**RECORD OF DECISION FOR THE
LANDFILL OPERABLE UNIT OF THE
TONAWANDA LANDFILL VICINITY PROPERTY
TONAWANDA, NEW YORK**

**AUTHORIZED PROJECT UNDER THE
FORMERLY UTILIZED SITES REMEDIAL ACTION PROGRAM**

September 2017

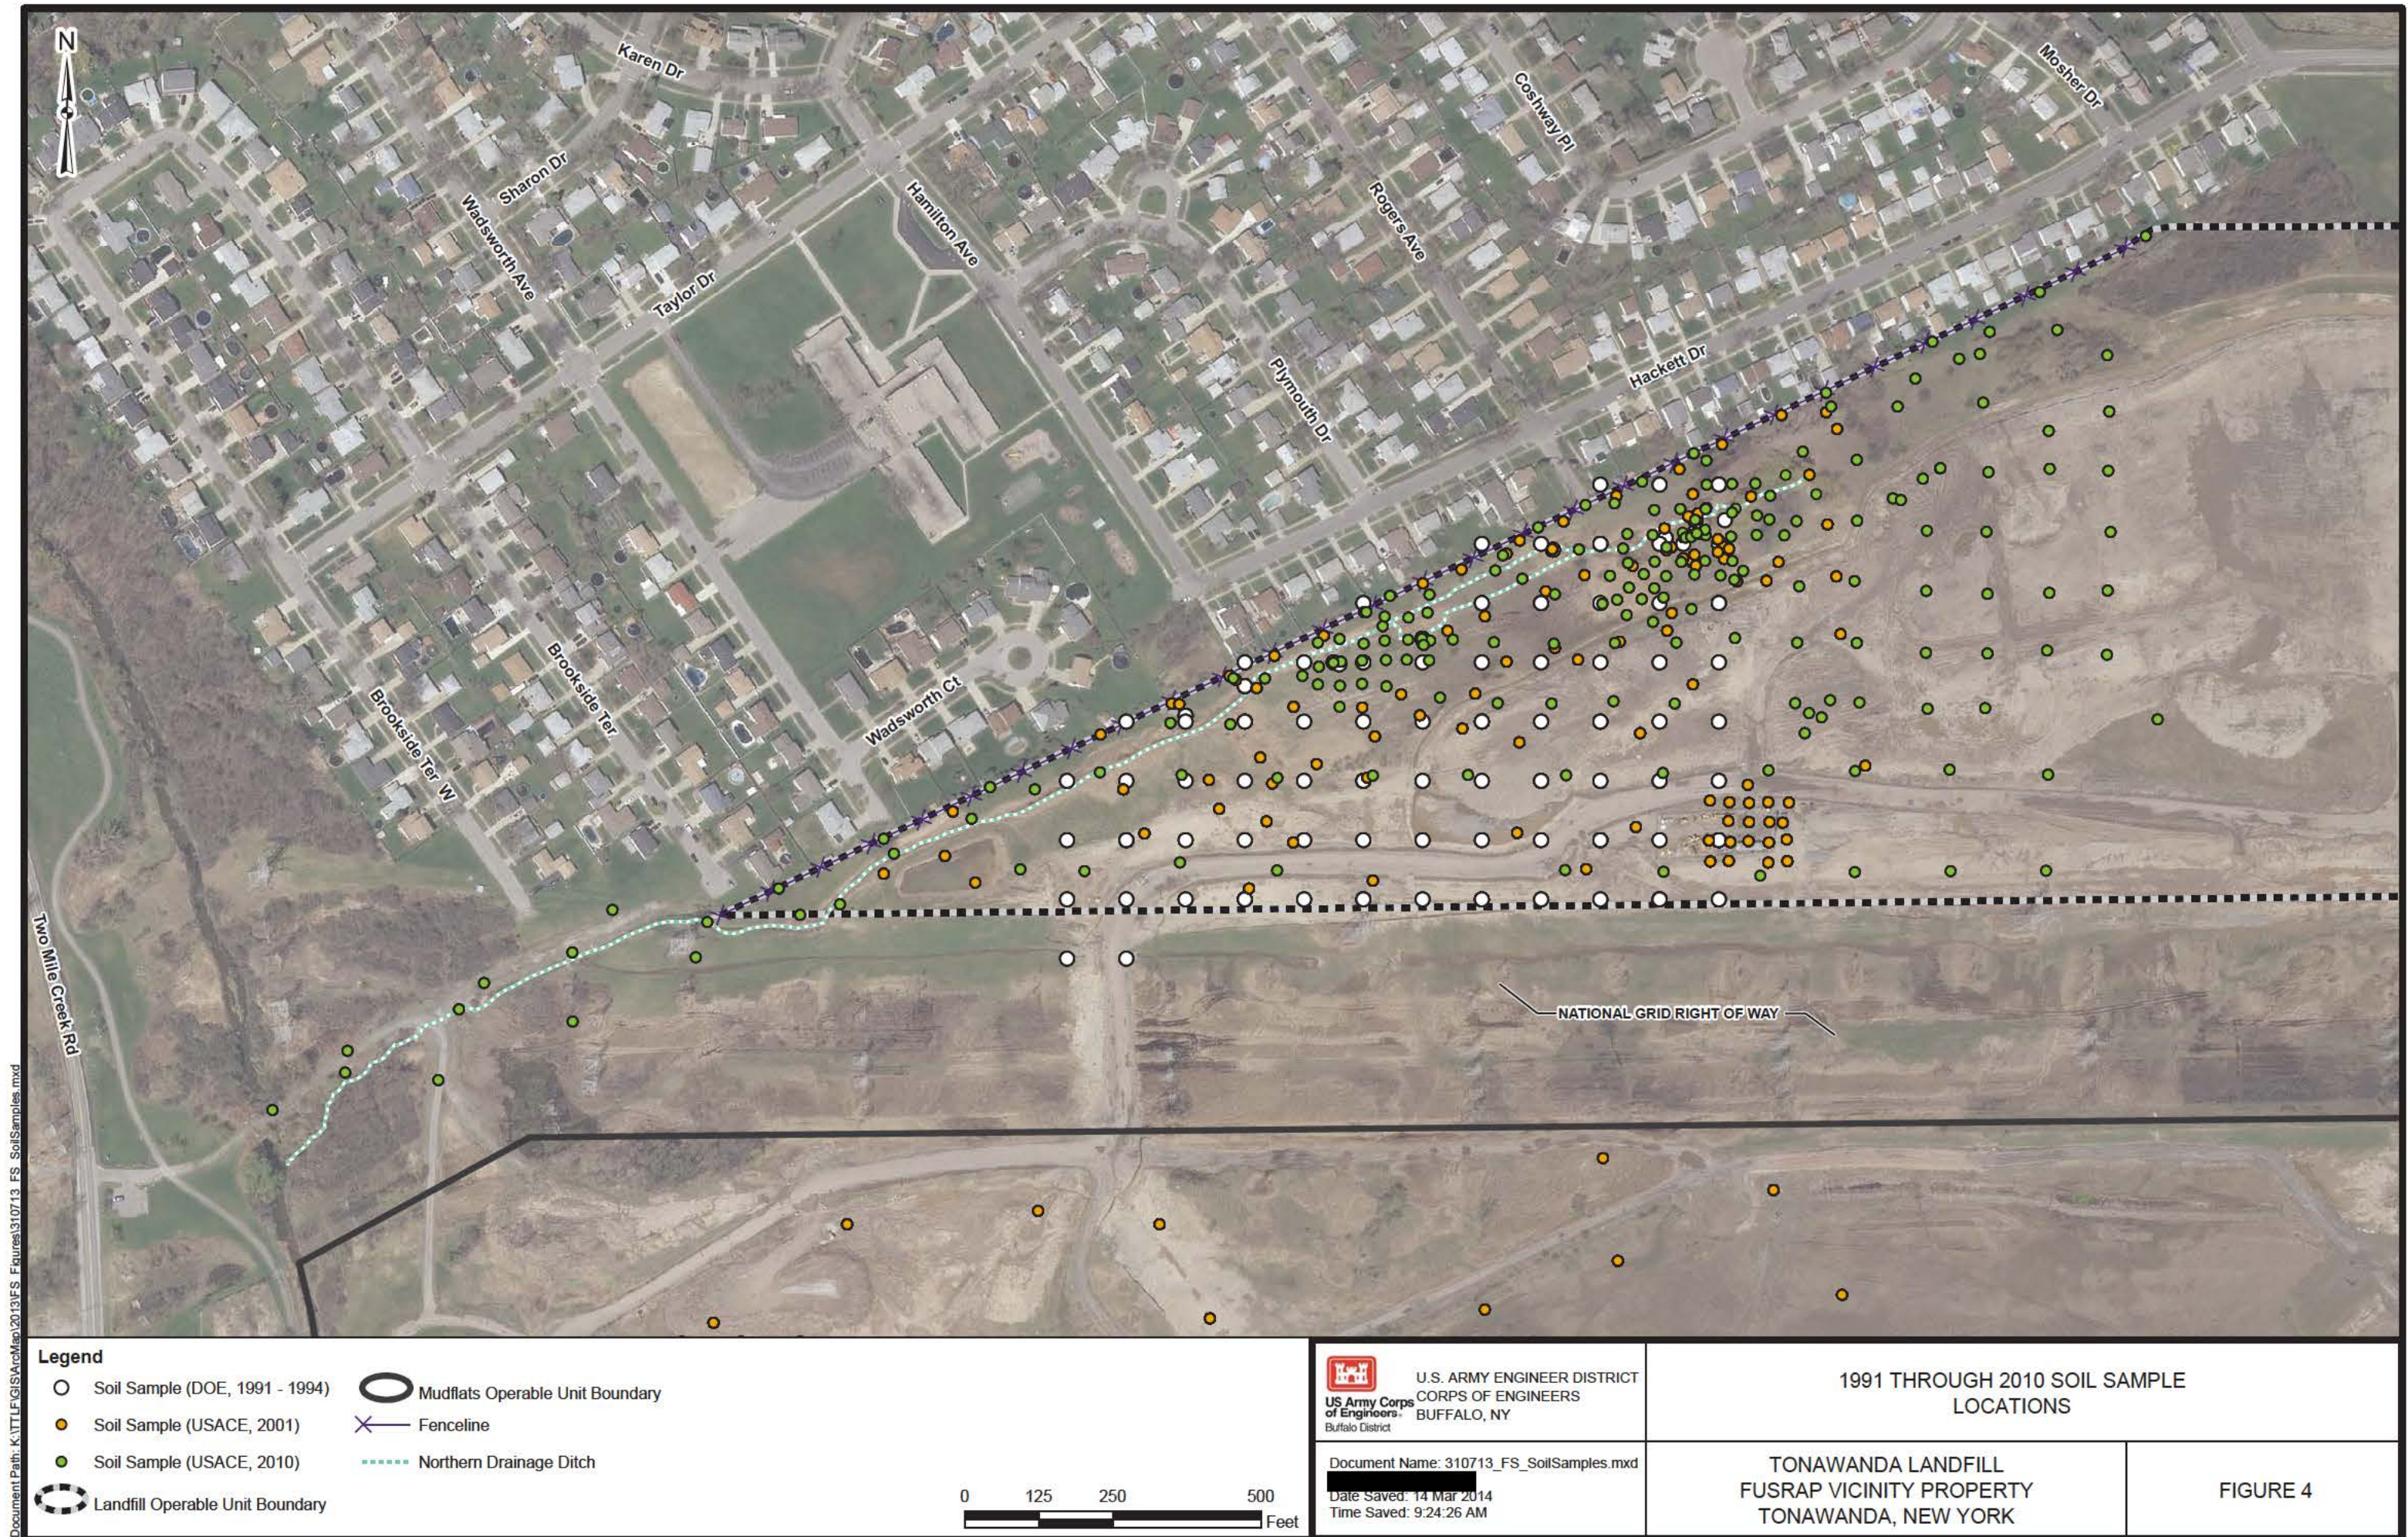
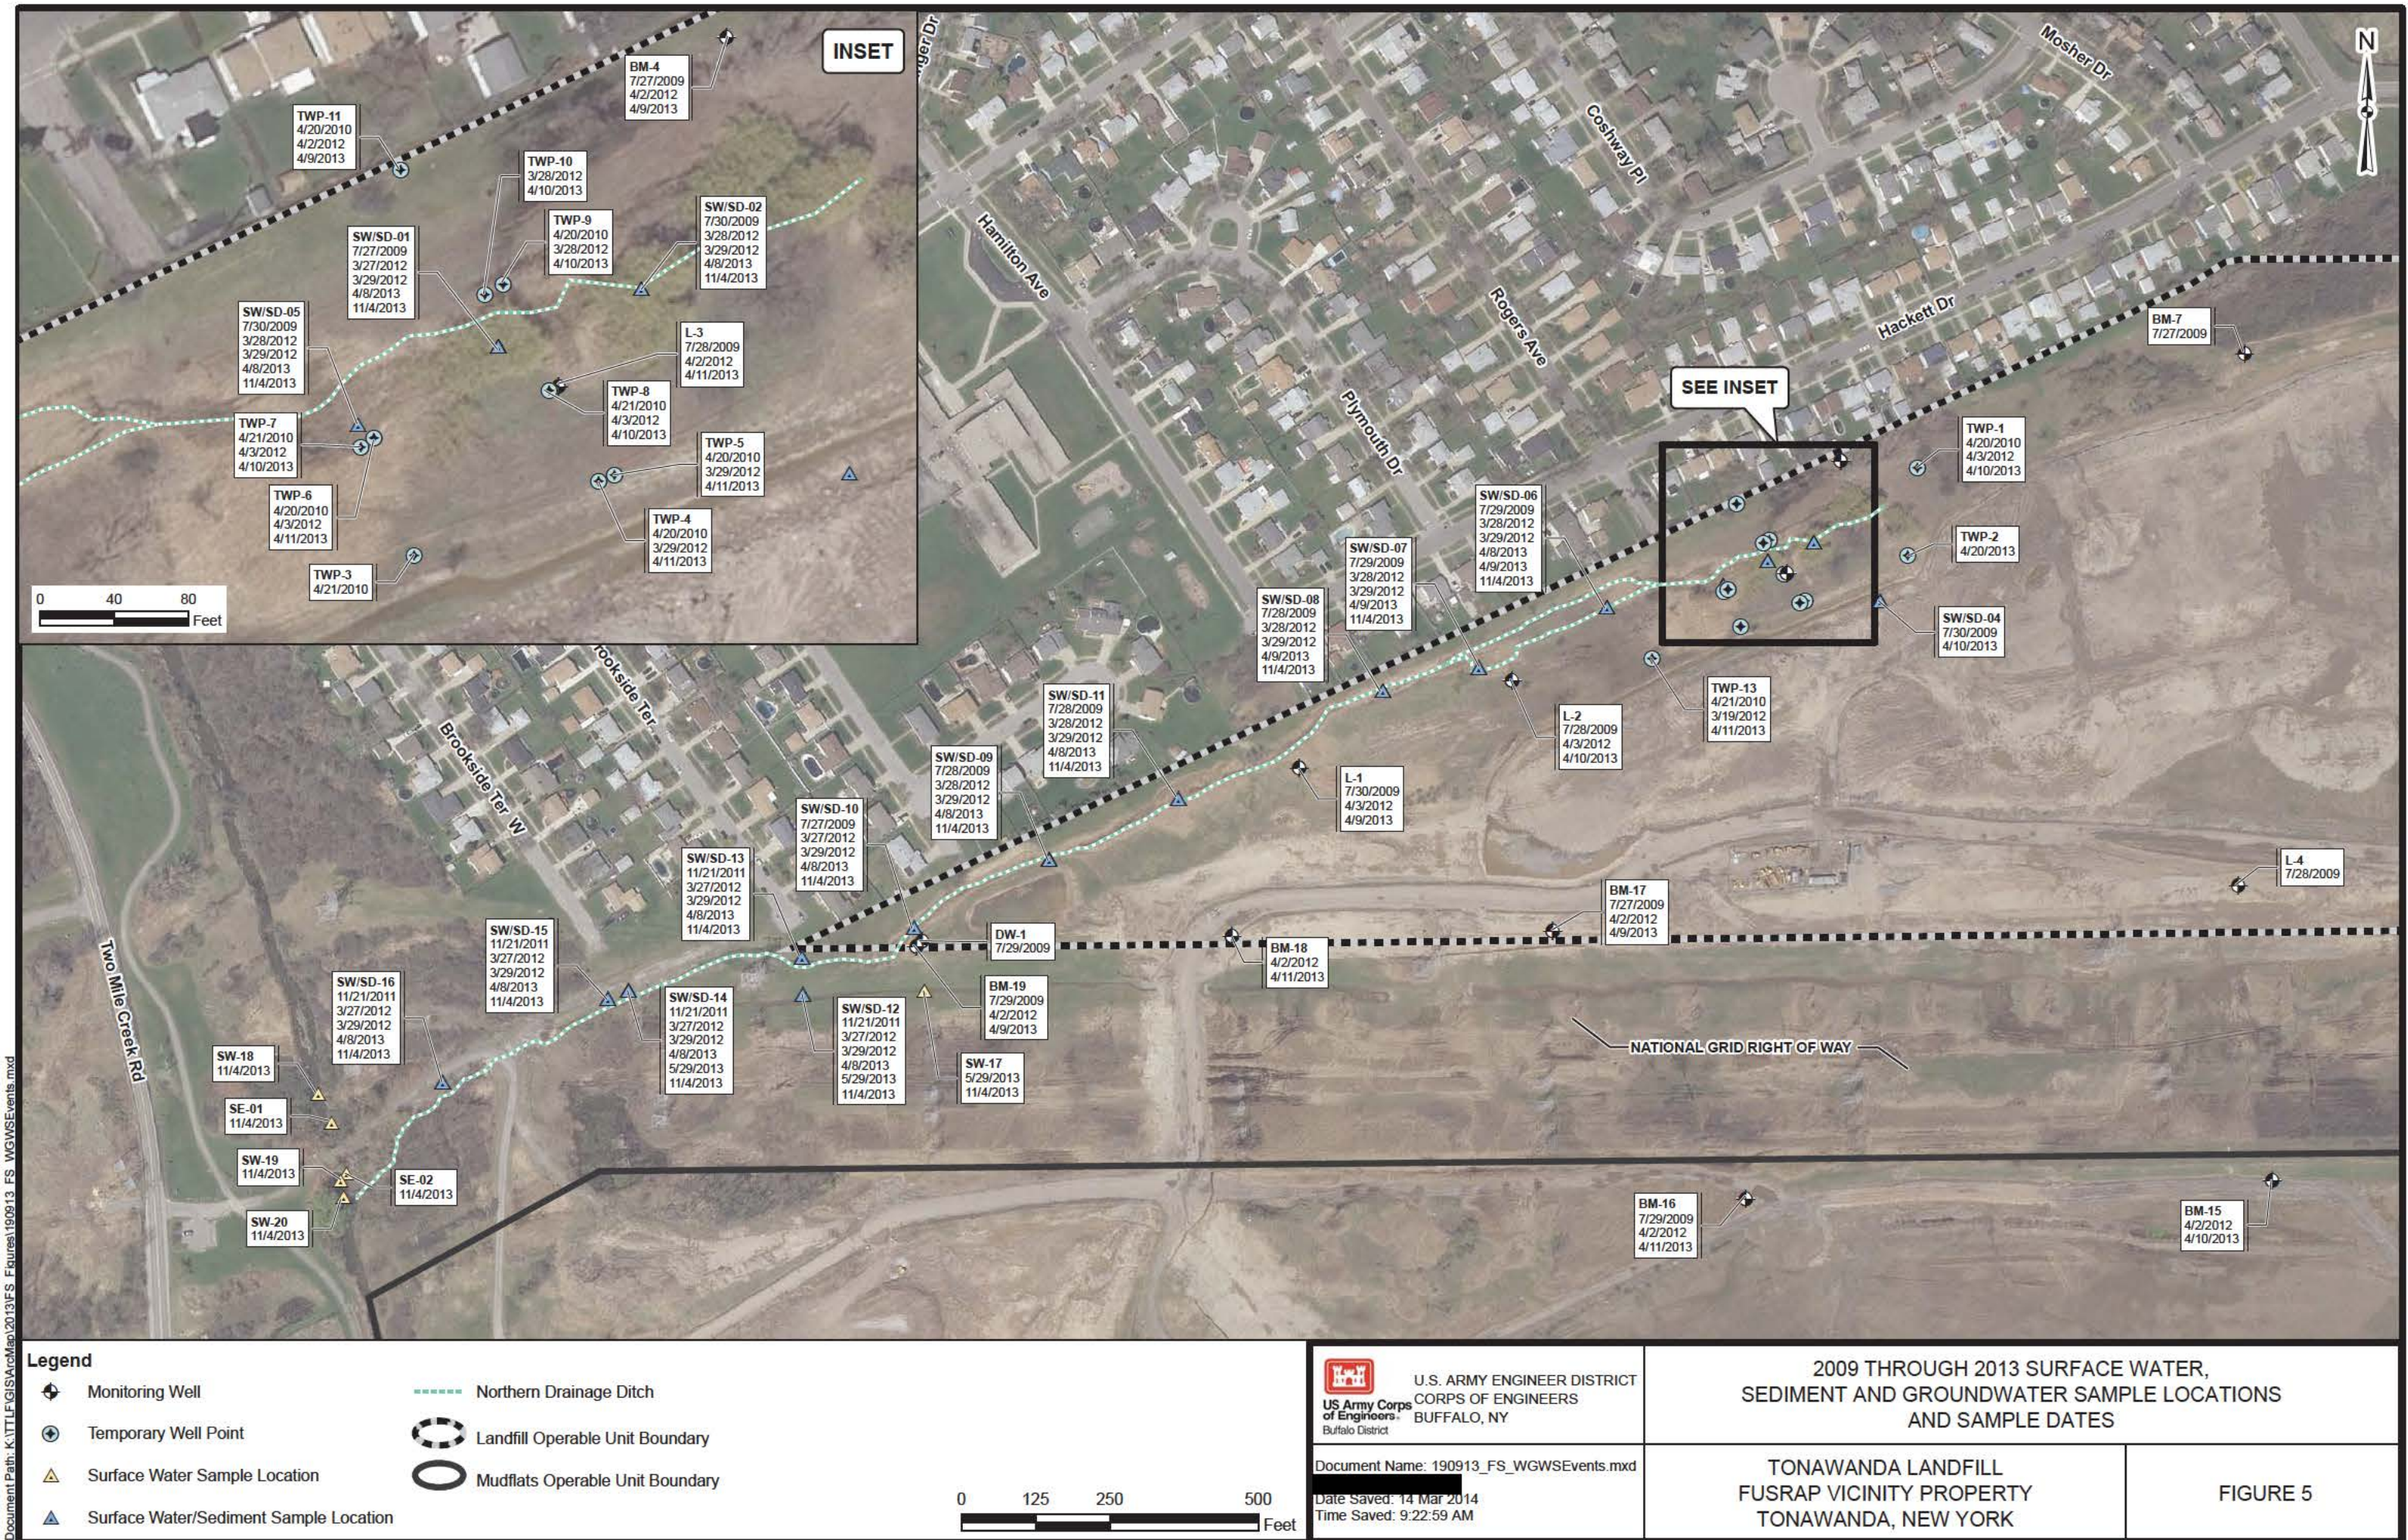
Appendix A Comment 29: The current Phase I capped area is larger than the area shown in Figure 3. The current Phase I cap extends south to the site haul road, and covers 27.8 acres as opposed to the 25 acre cap shown in the Corps figures and discussed in the text. Does this influence any of the model predictions, with respect to timing of plume movement?

Response Section 1.0 Comment 2: Figure 3 of the FS shows the total modeled extent of the FUSRAP waste in conjunction with the planned location of the Phase 2 cap. The FUSRAP waste appears to extend south of the perimeter fence that was erected by the Town. However, under Alternative 3, the proposed excavation footprint for FUSRAP waste does not overlap with the Phase 2 cap as shown in Figure 4 of this ROD. Also, see the response to NYSDEC Comment 4 to Appendix C of the FS.

Figure 1

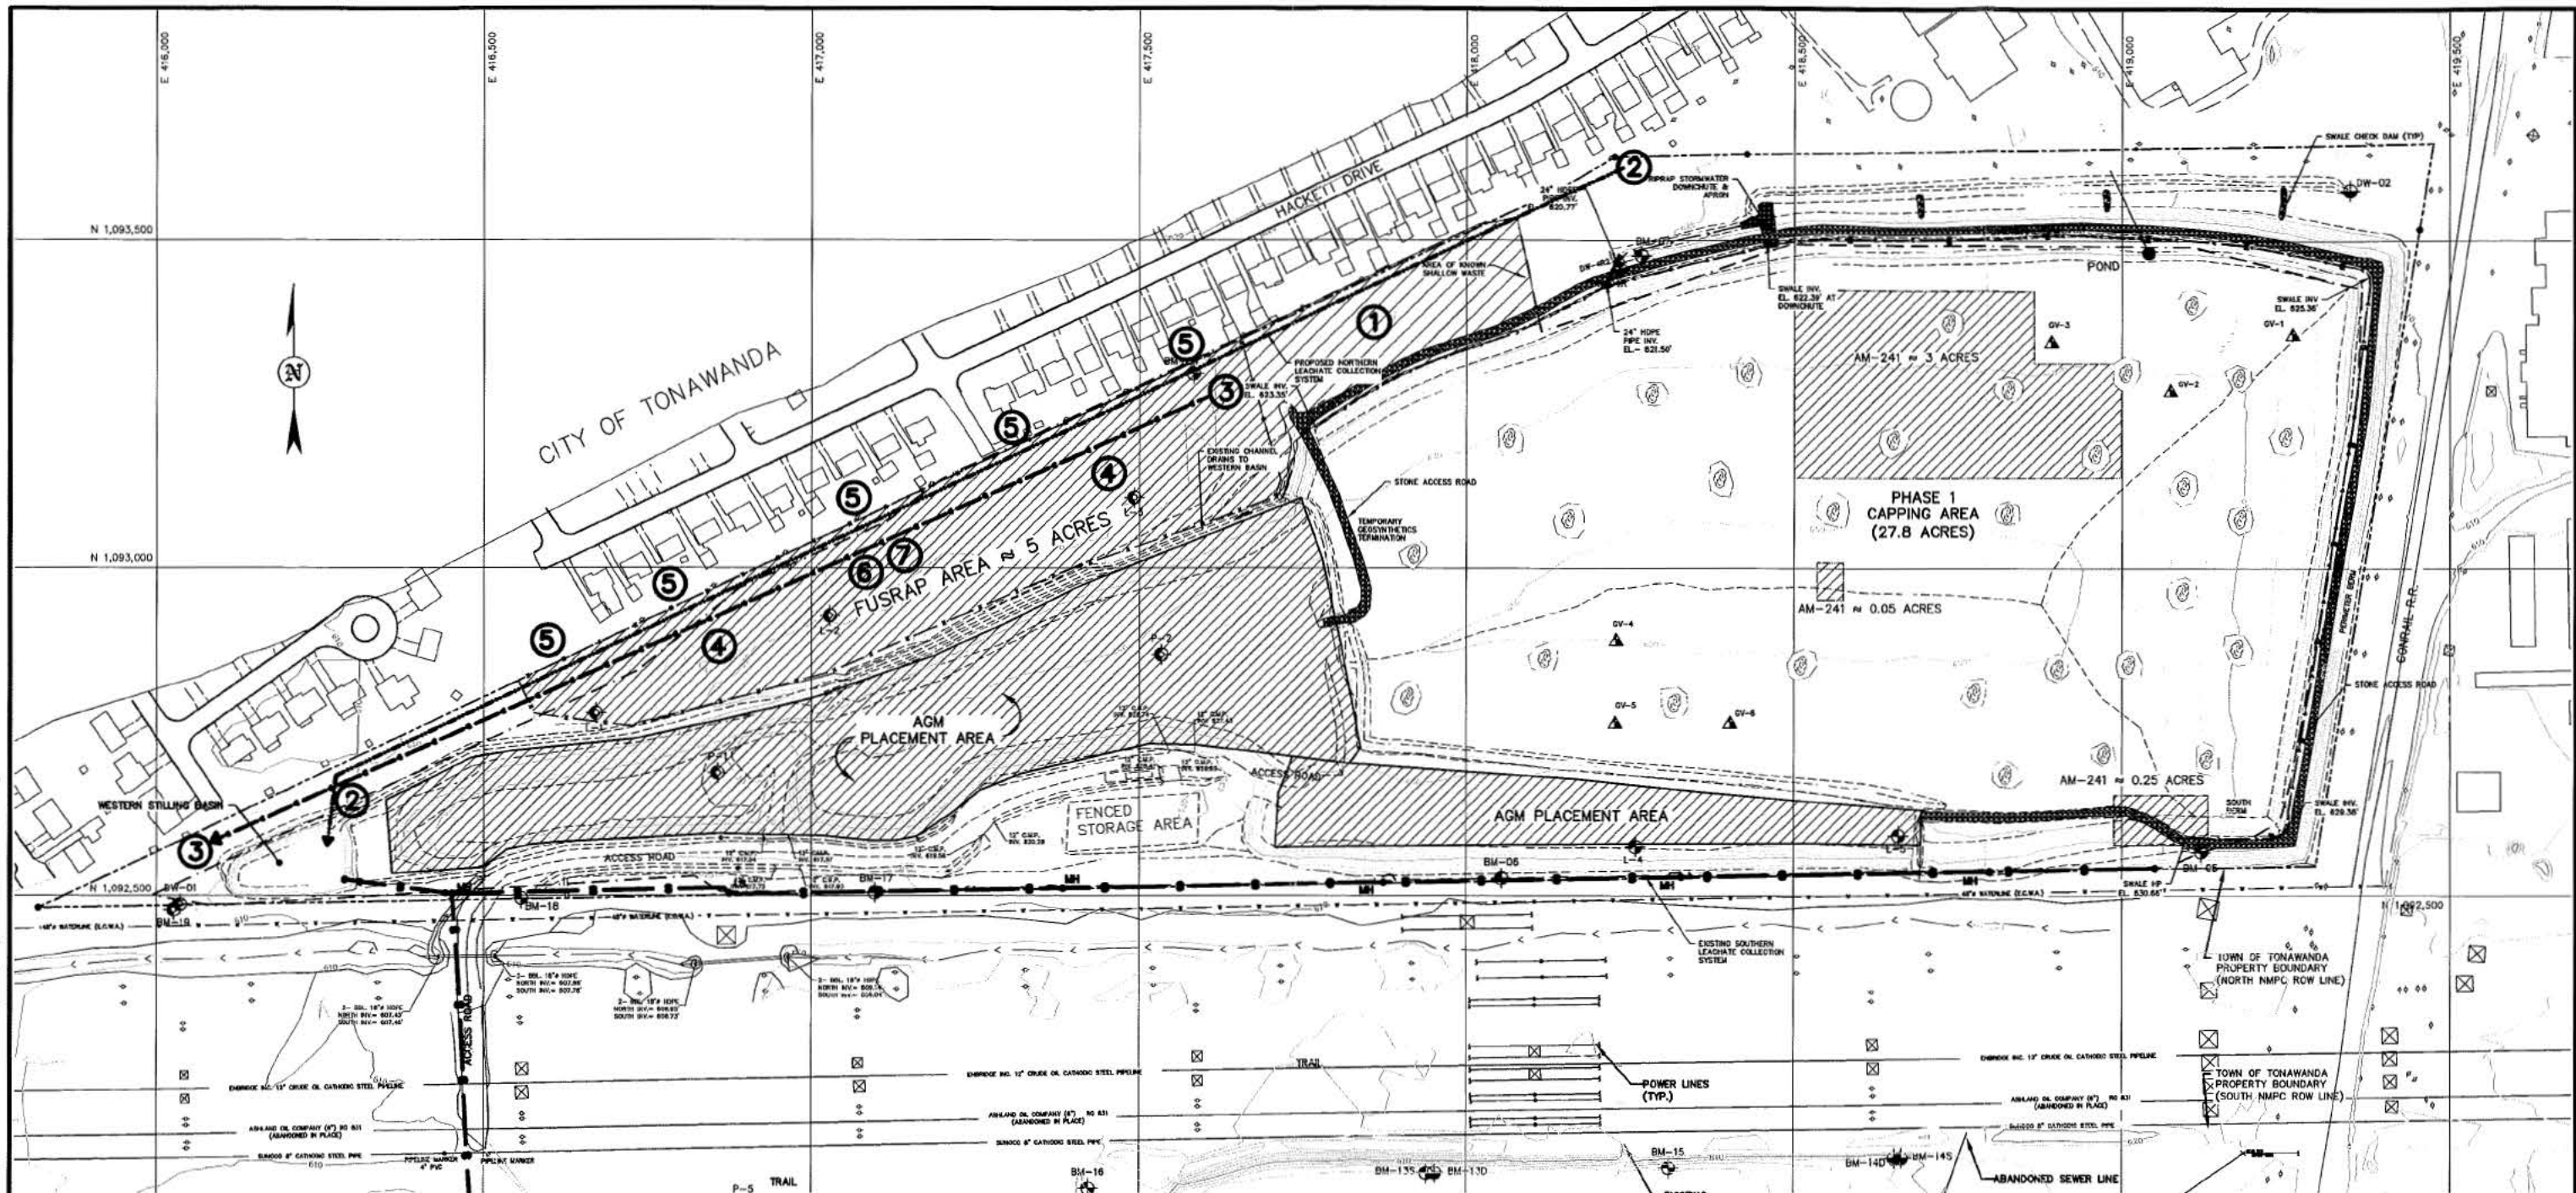
The following comments are in direct response to the Proposed Plan which documents the selection of Alternative 3: Targeted Shallow Removal and Off-site Disposal of FUSRAP-related Material as the preferred remedial method to address radiological contamination present in the FUSRAP area. Refer to Figure 1, attached, for a depiction of the following numbered comments.
